Solar Photovoltaic Systems Developer RFQ Questions, Responses and Clarifications

August 6, 2014

Hayward Maintenance Complex Component Repair Shop
Overall Site Improvement Plan &
Single Line Diagram Drafts

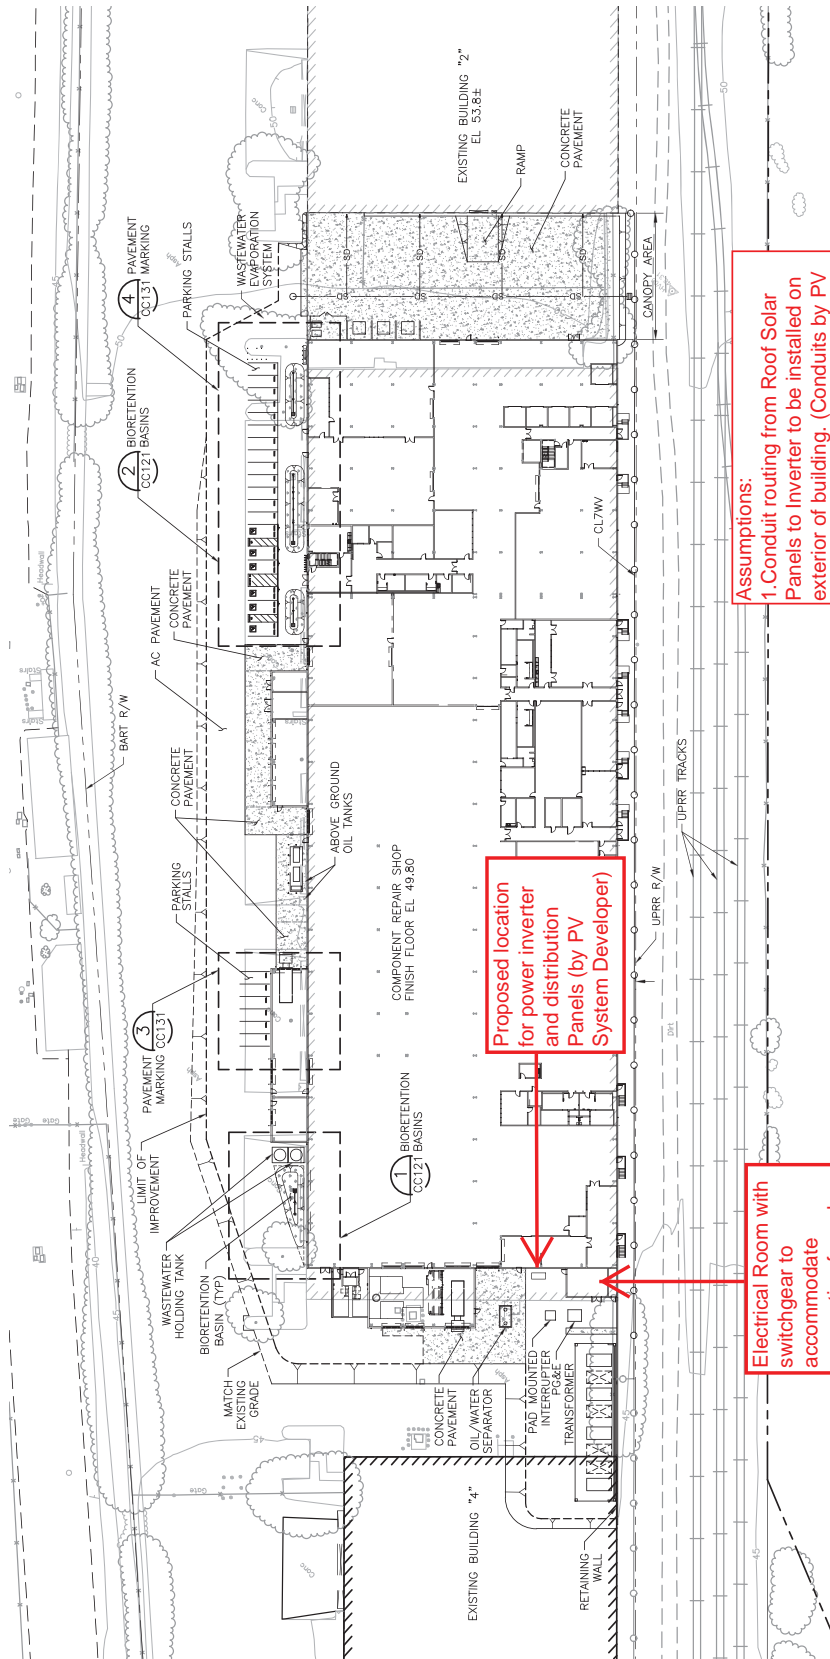
Attached are BART's most recent Component Repair Shop Overall Site Improvement Plan and Single Line Diagram drafts. The Site Improvement Plan shows a possible location for inverter and distribution panels subject to the selected developer's feasibility analysis. The Line Diagram shows provisions in the switchboard to connect the future solar system.

Proposed location for power inverter and distribution Panels (by PV System Developer)

Assumptions:
 1. Conduit routing from Roof Solar Panels to Inverter to be installed on exterior of building. (Conduits by PV System Developer)
 2. Need Solar System size and appearance layout to confirm inverter location.

Electrical Room with switchgear to accommodate connection for solar system. Conduits from switchgear to exterior of electrical room in 01RQ-110 Contract 4-4"C.
